RE: Revised Preliminary Site Plan Submission (S-22-03)
Steiner Land, LLC & Delstar, LLC
Tax Map # 135-16.00-23.05 & 23.06 (Parcels A1 & A2)
Georgetown Hundred
Georgetown, DE 19947

On behalf of Steiner Land, LLC & Delstar, LLC., Pennoni Associates Inc. (Pennoni) is pleased to submit the revised Preliminary Site Plan for your consideration of review and approval. We have addressed the following comments per your letter received on March 16, 2022.

STEINER ROAD INDUSTRIAL PARK (S-22-03)

PRELIMINARY SITE PLAN

PP1001

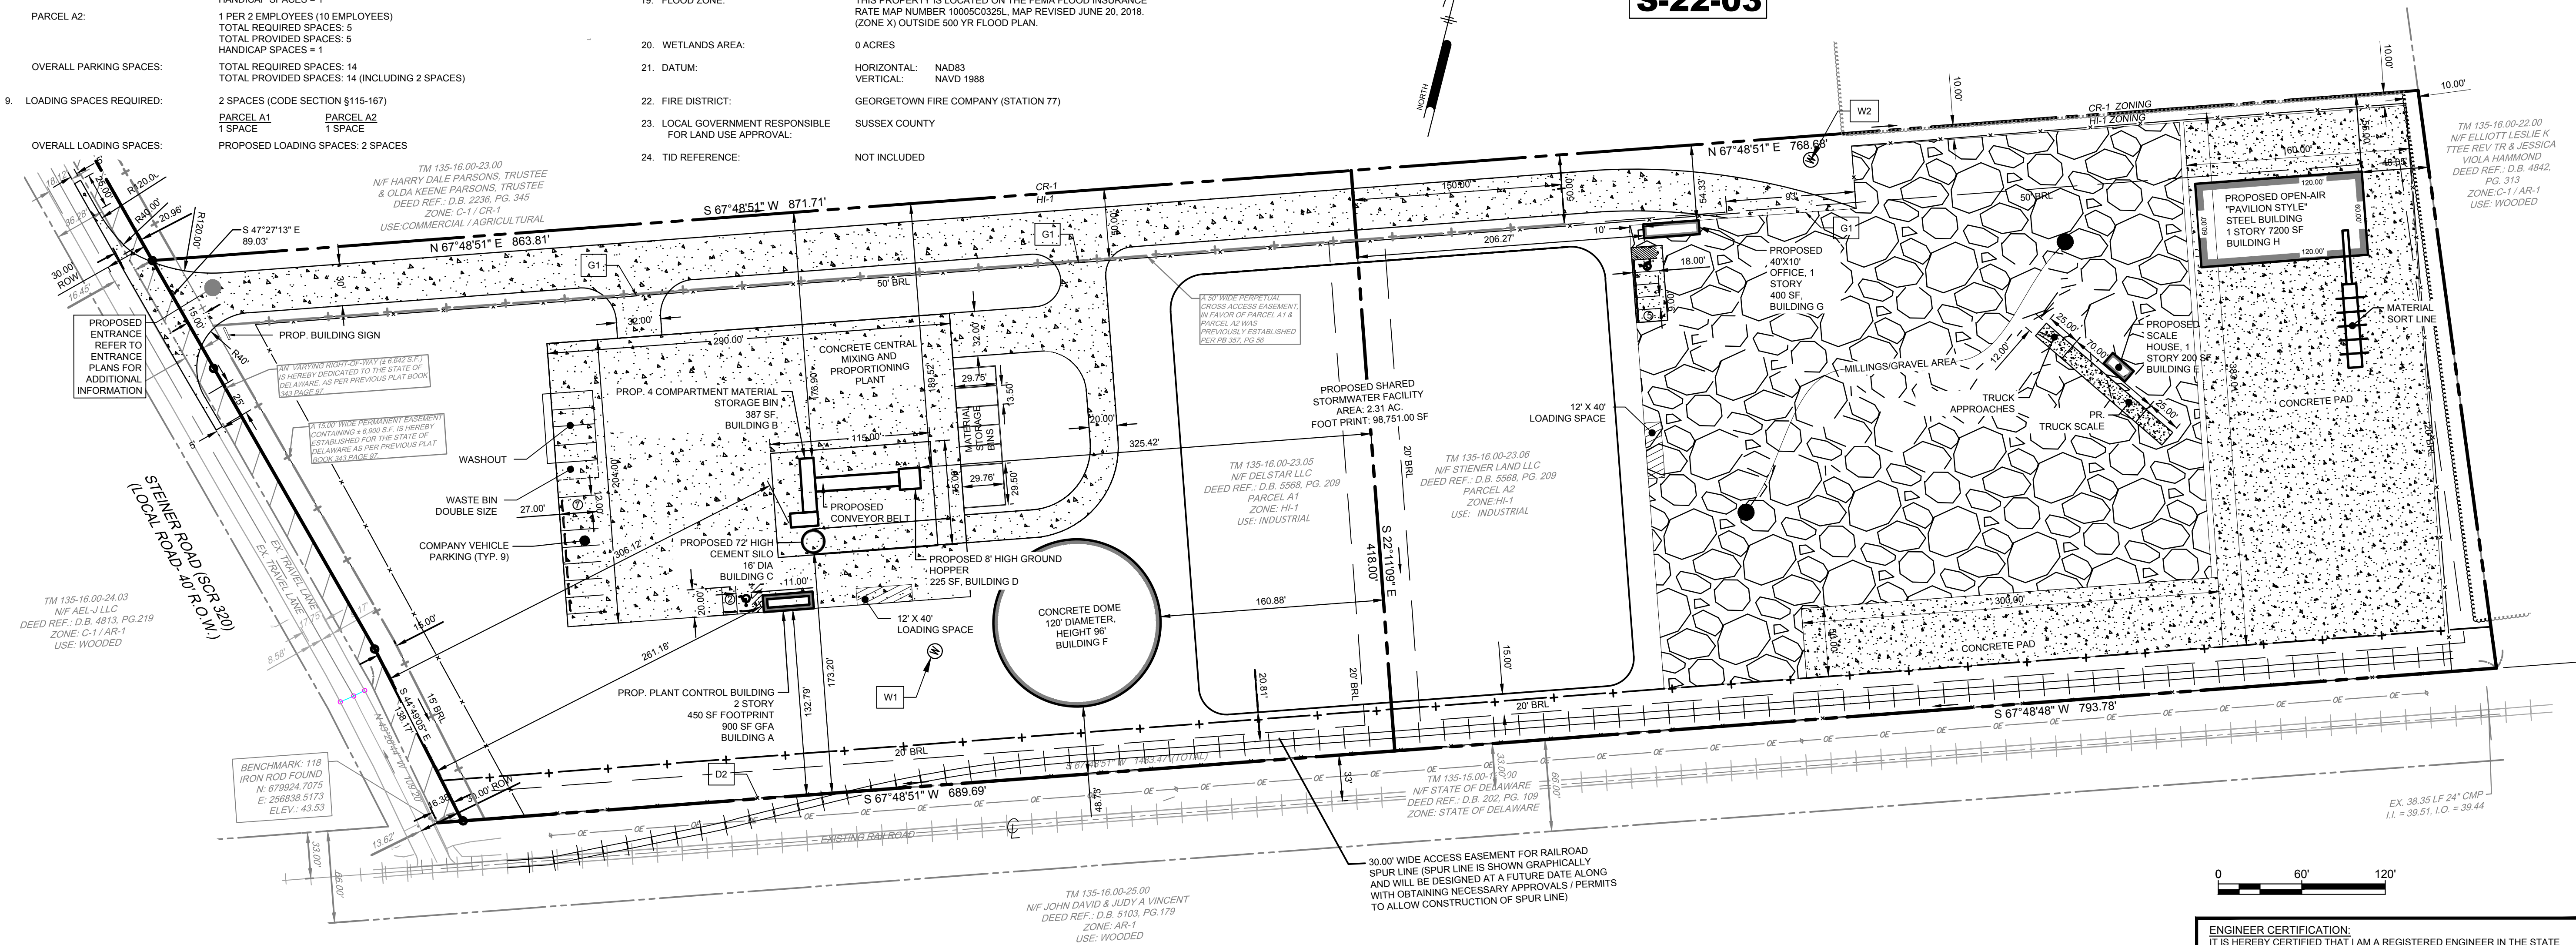
4. Staff notes that building height is not provided for all the proposed structures. Specifically, proposed heights are not provided for the following proposed improvements designated as follows in the Plan's "Building Use and Construction" table:

- Building B: "Compartment Material Storage Bin"
- Building H: "Open Air Pavilion Style Steel Building" – While the plan indicates "1 Story" for this structure, due to the unique nature of this improvement, staff request more specificity relating to the building and the proposed height.
- The improvement designated solely as "Proposed Silo", drawn as a circle immediately adjacent to the south of "Building C" in the Plan.

Please include the height for all proposed buildings on any revised plan (§115-220(8)).

5. Please provide more detail regarding the "Open-Air Pavilion Style Steel" structure. Will this be a rack type or lean-to style building? Will there be any type of component, structural or otherwise, spanning the top of the structure?

6. Staff notes the area labeled "Storage" on the Plan, immediately east of "Building D". Please provide more information clarifying the nature of the improvement in this area.

7. Staff notes that a total of seven (7) parking spaces are provided at two (2) locations in the plan. Staff requests that the applicant amend the Site Data column to include parking calculations or provide a parking table in the Plan indicating the calculations per the specific use of proposed structures as required under (§115-162).

8. Staff notes the parking area in the Plan adjacent to "Building A" designated as a (450) square foot "2 Story Plant Control Building." Staff notes that two (2) stories would imply (900) square feet in "Building A" which would impact the calculation of the total required parking at the site. Please clarify the total square footage to be included in the improvement designated "Building A." Additionally, please show the dimensions of the parking spaces provided at this parking area as well as the dimensions of the parking stalls at the area labeled "Company Vehicle Parking" in the plan.

11. Please show the required front yard setback of fifty (50) feet in the plan. (§115-220(8))

Pennoni Response (April 22, 2022): We have added the height of all structures and building, refer to the building use and construction table.

Pennoni Response (April 22, 2022): The building will be a pavilion style building, basically a roof supported by post/columns around the perimeter with no side walls.

Pennoni Response (April 22, 2022): The label has been revised to state Material Storage Bins, these bins will store the various materials and aggregate for the cement mixing process. Refer to the Chaney Site in Lincoln for additional information.

Pennoni Response (April 22, 2022): The parking has been separated for each use and clearly identified on the plans.

Pennoni Response (April 22, 2022): The parking is based on employees not square footage. We have updated the Building A label for total GFA along with parking dimensions as requested. The parking data has been separated and clearly references the required and proposed for each site.

Pennoni Response (April 22, 2022): The 50' wide front setback is shown on the plans and follows the previous recorded plat as part of the minor subdivision. The front setback following the property line parallel with the access road. The setback along Steiner Road is 15' as this is a corner lot per the recorded minor subdivision plan.
